METROPOLITAN GOVERNMENT OF NASHVILLE AND DAVIDSON COUNTY

STAFF RECOMMENDATION

1226-1228 4th Avenue North

Application: New construction - infill

Figure 5: Proposed setbacks compared to existing setback. Solid blue and green indicate existing setbacks and dashed red line is approximate proposed setback.

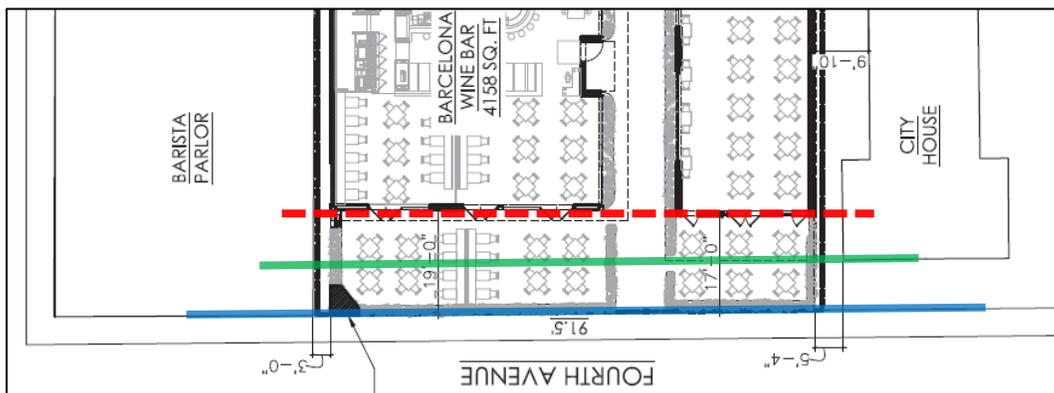
~~These setbacks are each one foot (1') shorter than in the proposal that was disapproved by the Commission in May.~~ Staff finds that these setbacks contrast greatly with the adjacent buildings: the commercial building to the left sits at the front edge of the

property and the residential-form building to the right has a nine foot (9') setback, which is the greatest setback on the block face. Staff finds that the project does not meet section 3.1.1 and 3.1.4 of "general principles" which states that buildings should be sited in a way that is appropriate for their context and the context they create. In this case, the project does not meet the commercial context setback nor the more prevalent setback established by the buildings that were historically constructed as residential buildings.

The design guidelines encourage front seating areas for commercial buildings to enliven the streetscape but it also states that it is important to avoid arbitrary establishment of setbacks resulting in "haphazard building placement and a resulting interruption or absence of visual order within the District." In this case, the proposal has deep setbacks are not typical of the immediate area. In the past, the Commission has generally used the historic buildings to assure that a new front setback is not "haphazard." When that has been unavailable or inappropriate, the Commission has used an average of the block face instead. Staff finds that the front setbacks of the proposal are not compatible with the surrounding context and therefore do not meet sections 3.1 and 3.2 of the Germantown design guidelines.

SITE PLAN

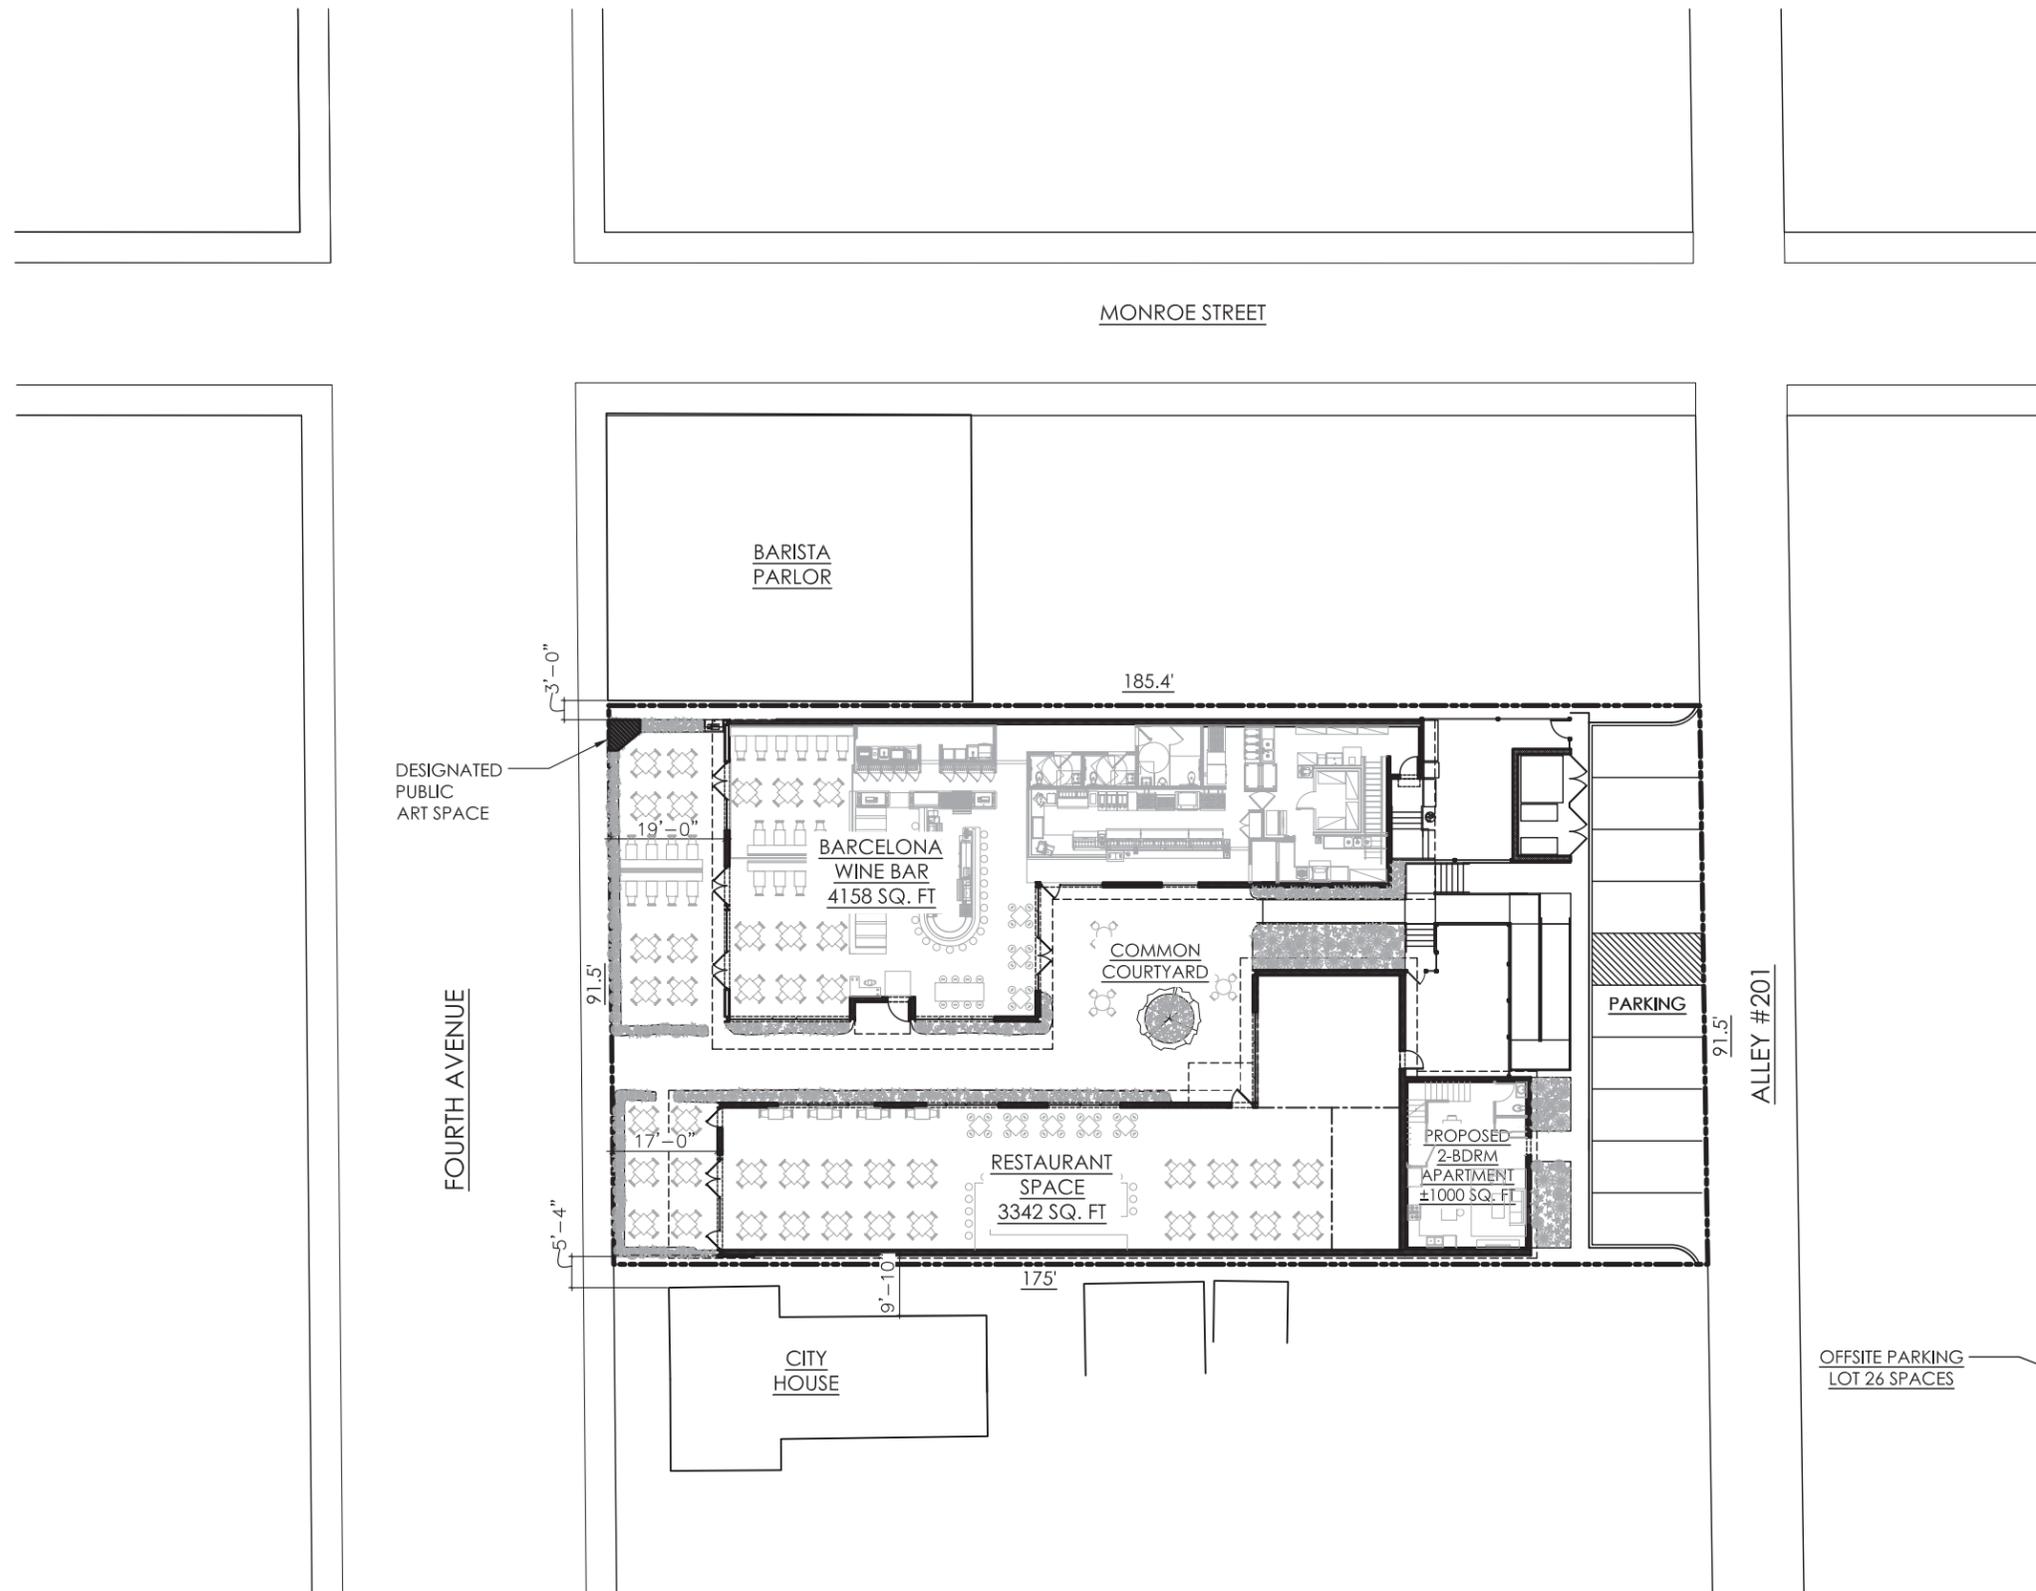
General Principles, Site & Building Planning, Setbacks: The proposed setbacks have changed just one foot (1') from the previous proposal. The new buildings will be fronted parallel to the street and will be shifted toward the sides of the lot with a thirteen foot (13') wide walkway between them. The left (northern) building will sit nineteen feet (19') back from the sidewalk. The building to the right will sit seventeen feet (17') back from the sidewalk, eight feet (8') greater than that of the house to the right. The setbacks among the historic context on this block face range from one foot (1') to approximately nine feet (9') from the front property line.

Orientation: The front facades will be separated from the sidewalk by front patios enclosed by hedges and the primary entrances to the buildings will be from the sides, accessed through the central walkway. Stone bollards will mark the opening to the walkway at the edge of the sidewalk. Staff finds these front yard features are more typical of a suburban development, than an urban setting, and that the new buildings would not directly engage with the street as required by section 3.2.3 of the design guidelines. This guideline does make an allowance for residential developments to utilize courtyards, but is clear in stating that the appropriate orientation for commercial buildings is to have primary entrances that directly engage the street. Areas for street furniture can be appropriate; however, in this case, the depth of the front setback, patio and landscaping together create more of a private rear patio space than an urban street front. Although both buildings have doors on the front façades, they are not given the emphasis typical of doors on a storefront; they lack bulkheads or kick-plates, they are not recessed or articulated from the primary plane of the façade, and there is no direct walkway or connection from them to the sidewalk. Instead, they read as operable windows rather than principle entrances.

ROOF PLAN

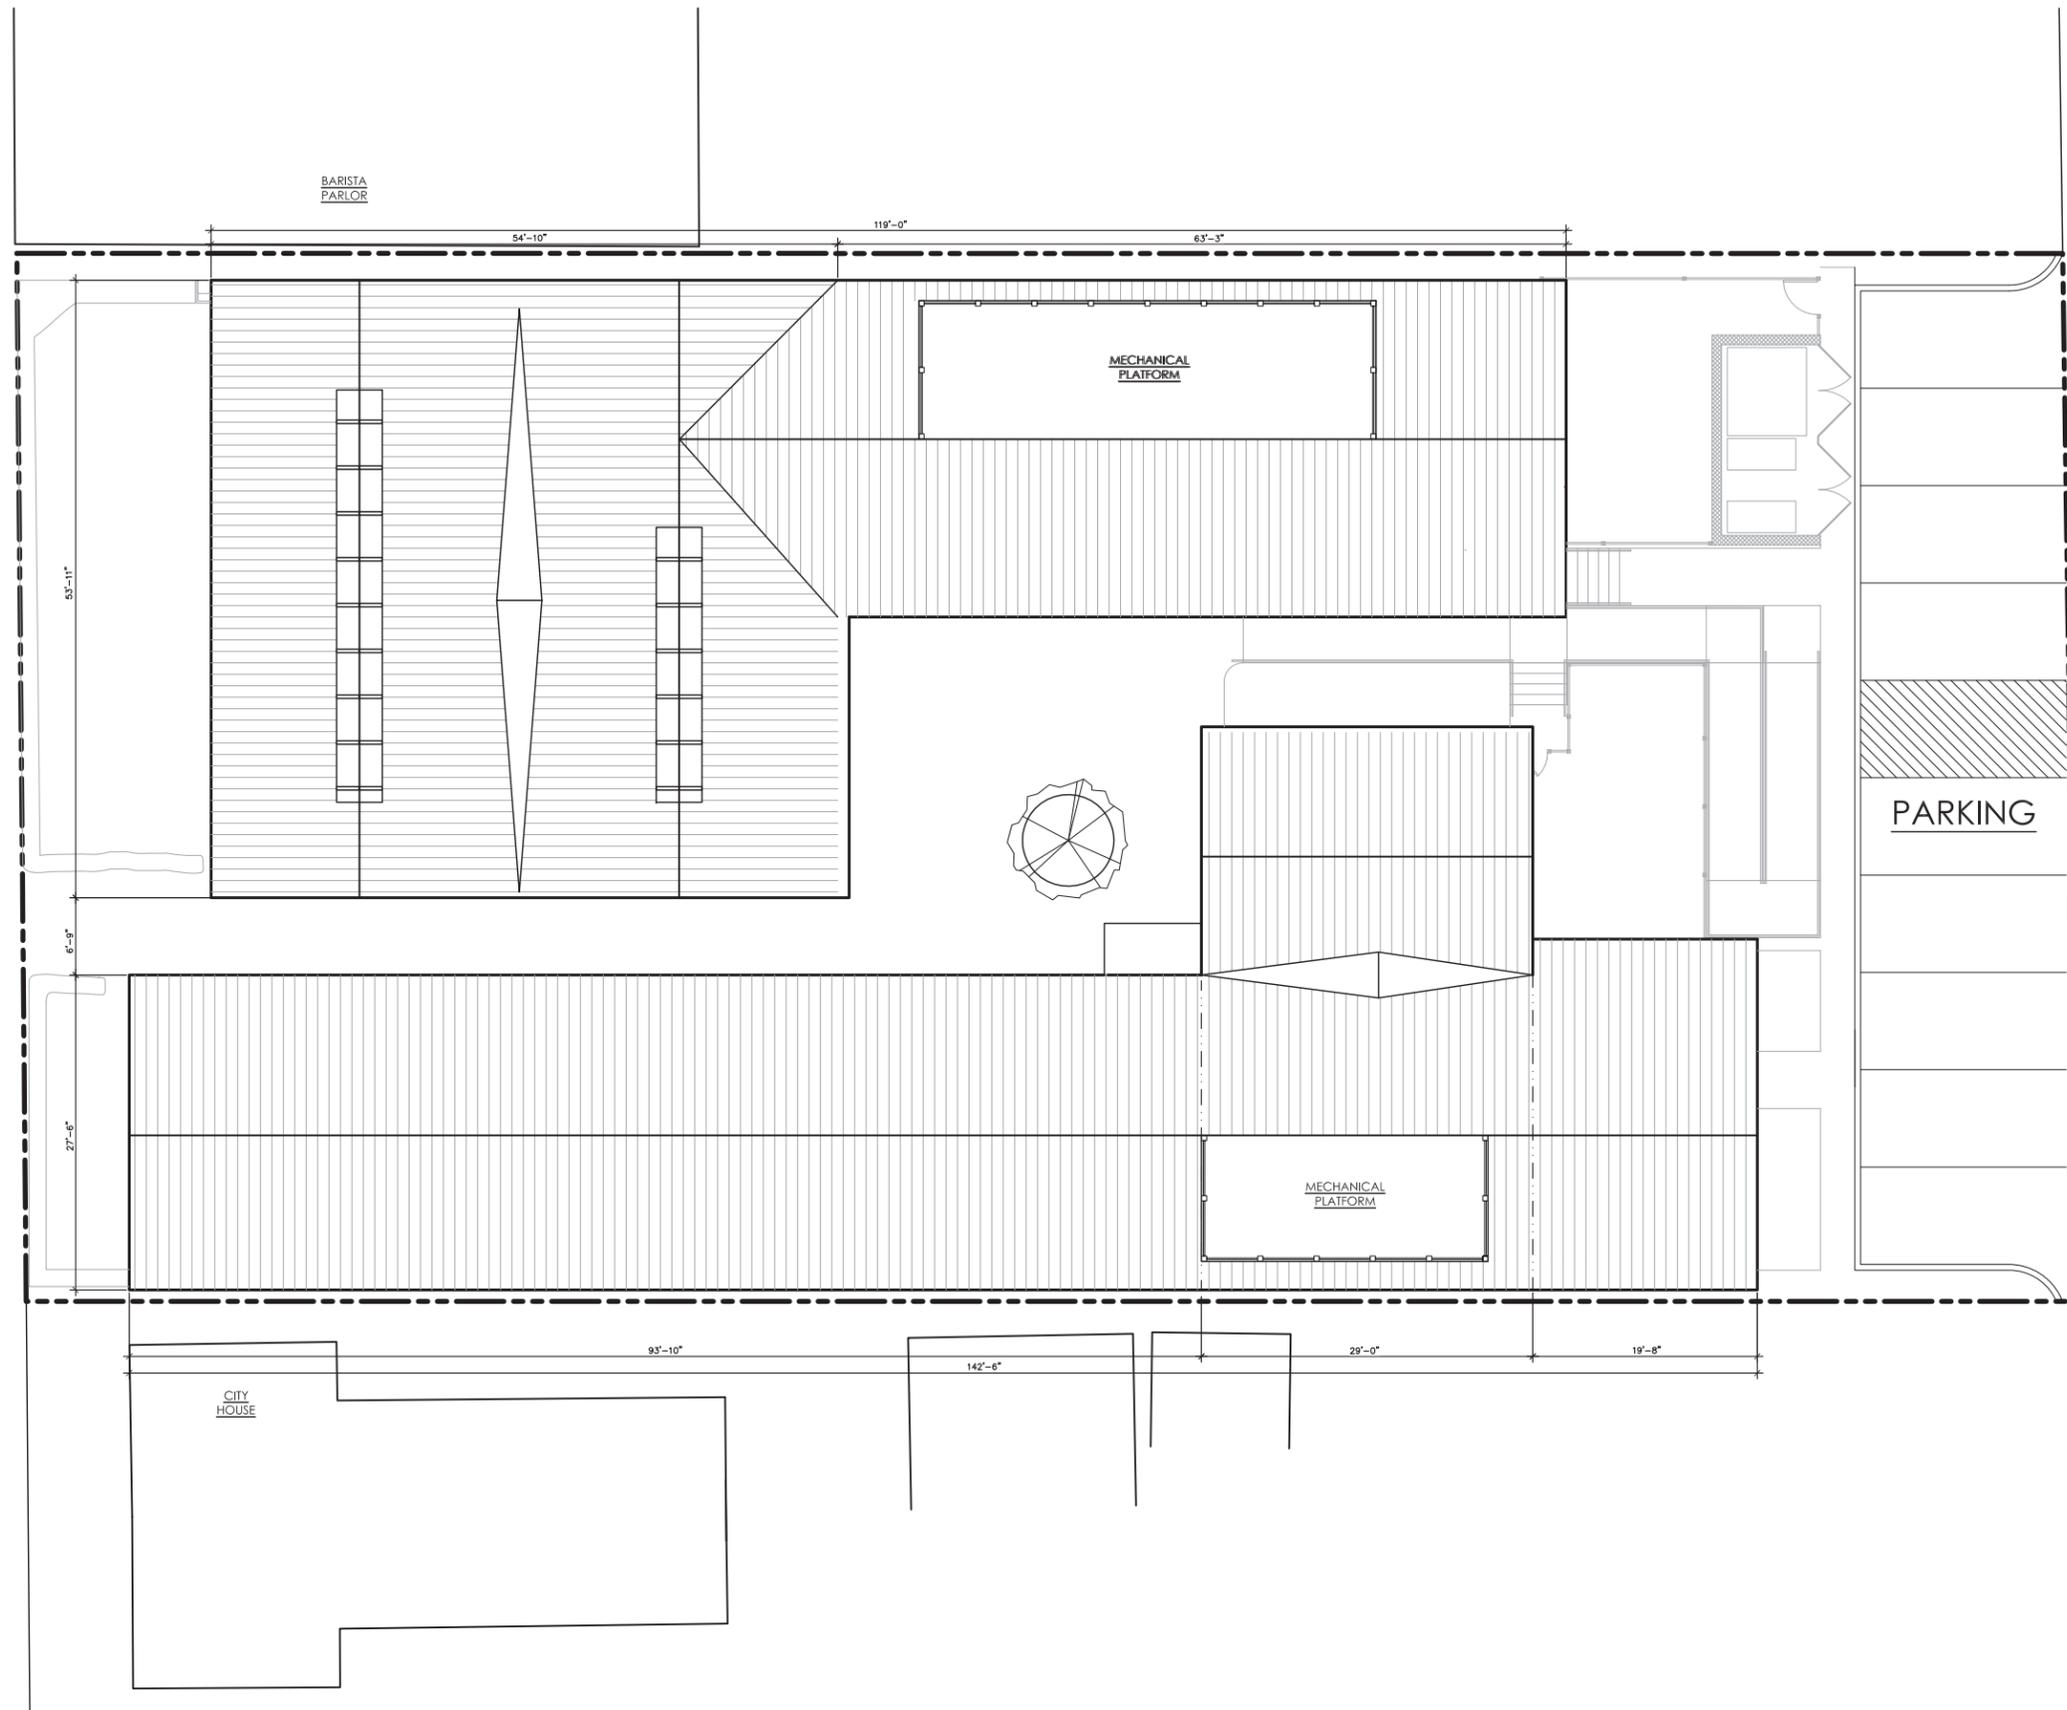
Roof: Both buildings will have gabled roofs, the left building with a side-oriented ridge and the right building's roof ridge oriented toward the front. The pitch of both roofs will be approximately 6:12. The form and pitch of the roofs is similar to historic buildings nearby. As depicted in the submitted roof plan and renderings, the roof of the left building will have a large skylight over the majority of the roof ridge. This does not meet section 3.6.1 of the design guidelines which states that skylights should be located behind the midpoint of a building so as to minimize their visibility.

EXTERIOR ELEVATIONS

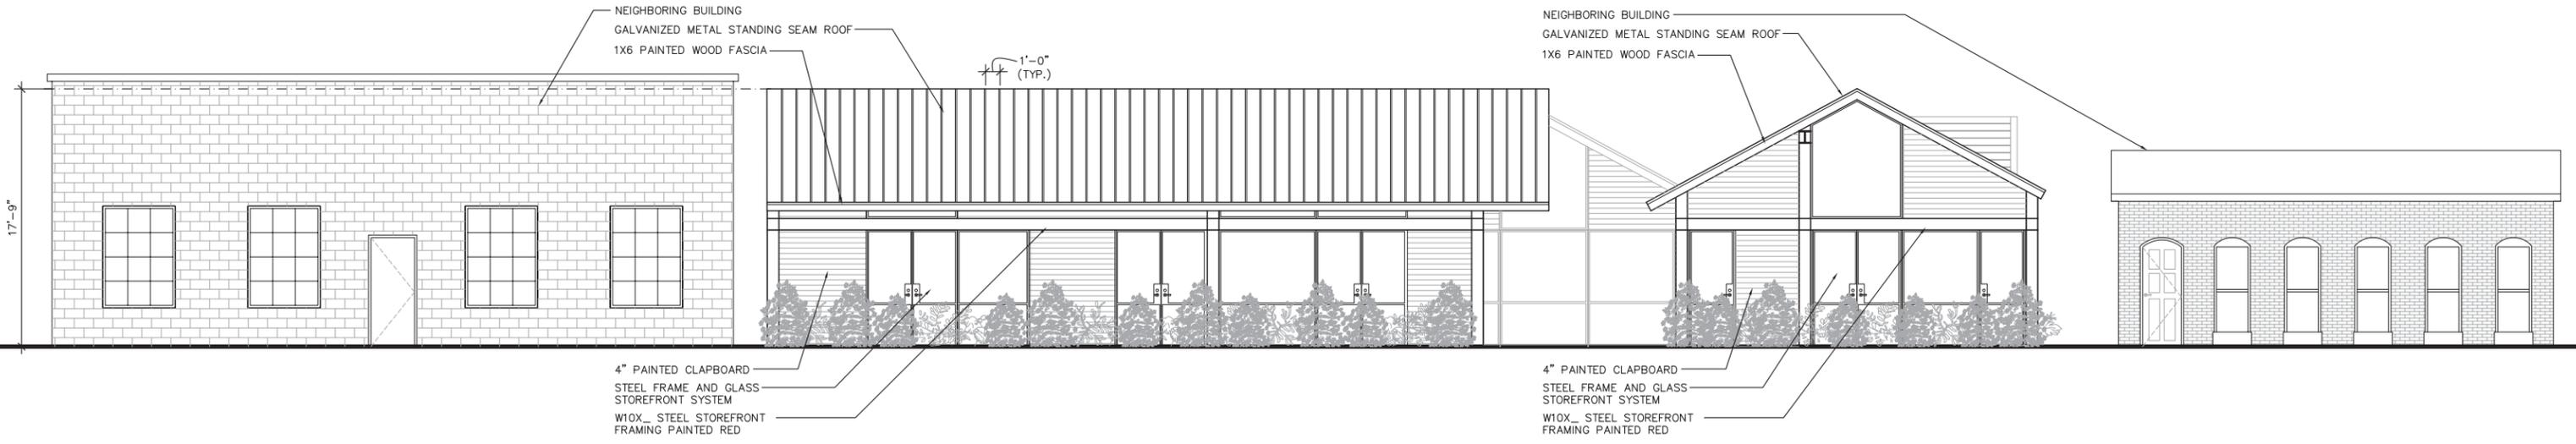
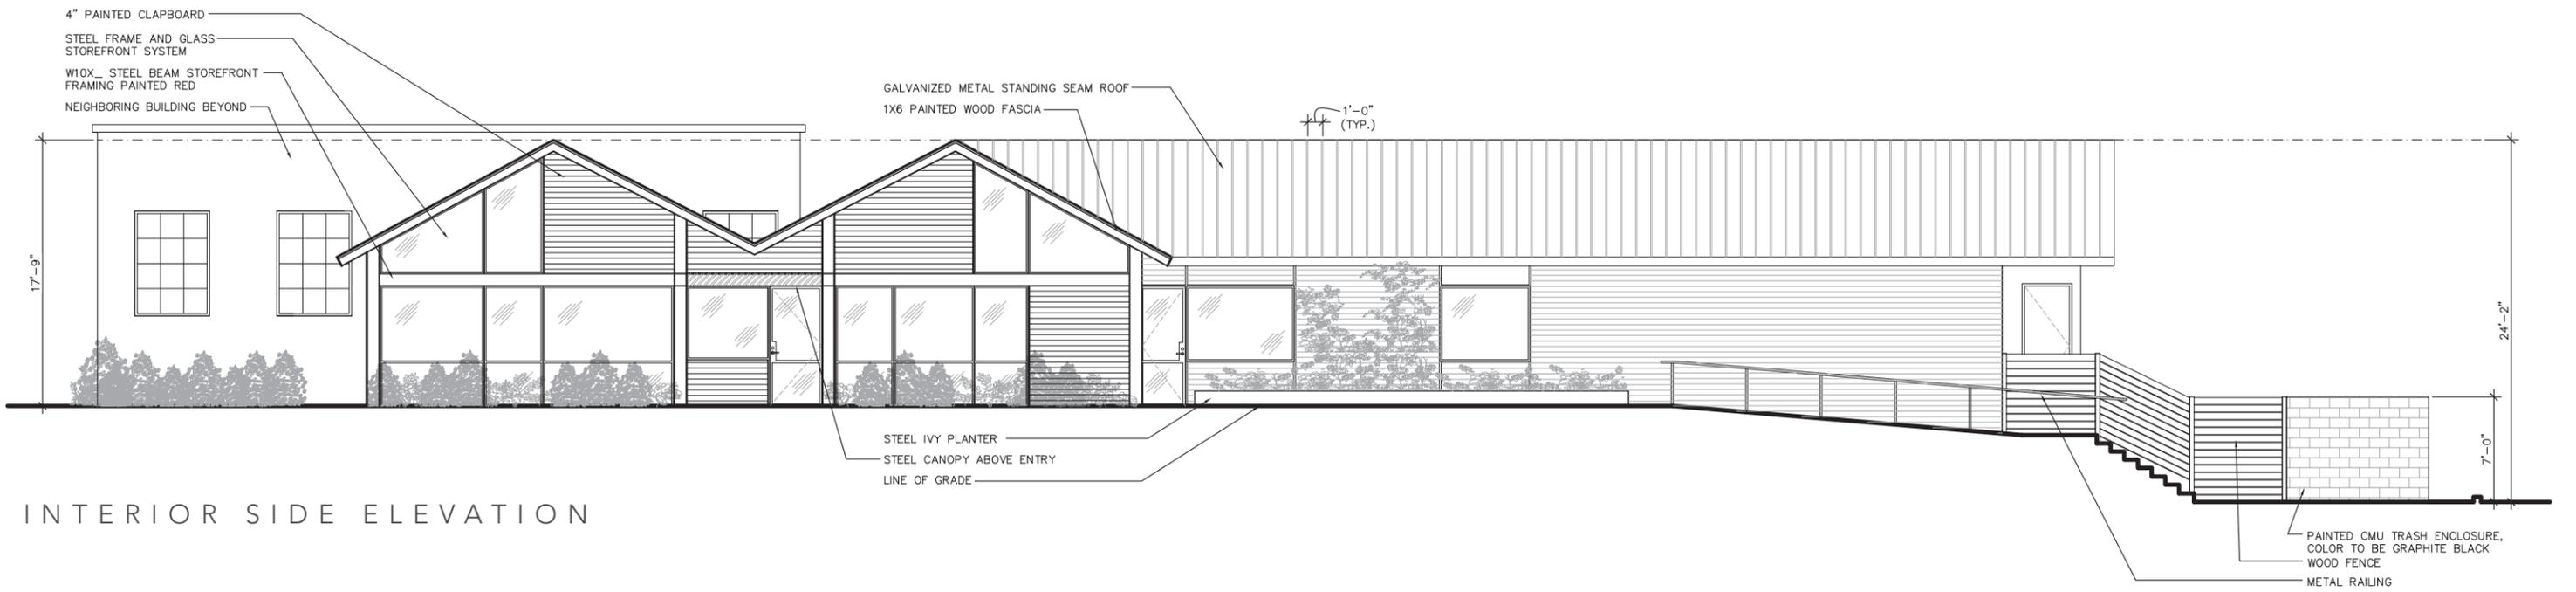
Façade Articulation: The front elevations will have sections of solid wall between sections of windows and doors. Each of these façades will be more than sixty percent (60%) glass; Staff finds that this balance of walls and openings is compatible with that of historic buildings in the area. The design guidelines call for design techniques that avoid large expanses of unbroken façade plans and/or materials in two sections of the design guidelines. Staff finds that the articulation of the front facades would generally meet section 3.2.4.2; however, the windows themselves do not meet the design guidelines. Please see the next section on "windows."

Windows: The windows on the front facades of the two buildings are horizontal in their proportions and rhythm, which is not in keeping with the windows of typical commercial context historically. Additionally, the building on the right will also have a large window in place of the gable field wall at the front. The proportion of a floor-to-ceiling wall is not typical of the built environment in Germantown and does not meet section 3.1.6 of the design guidelines.
